### Changes made to TempTrackr<sup>TM</sup> System for FCC Compliance

## Unused antenna ports deactivated by Software: User can not select other ports

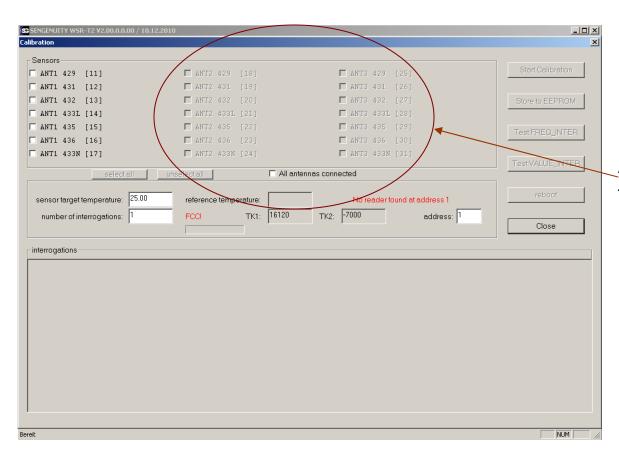
## Heatshrink over primary antenna connection

- FCC requirements impose the following restrictions on the reader:
  - The reader will read sensors only once every 30s.
  - The reader will only make use of one antenna. The other two antenna ports are deactivated on FCC compliant readers.
- CE requirements restrict the reader to only operate in the 433 MHz ISM-Band. This means that you will only be able to read one sensor with a CE compliant reader.

Antennas 2 & 3 Deactivated for FCC compliant readers
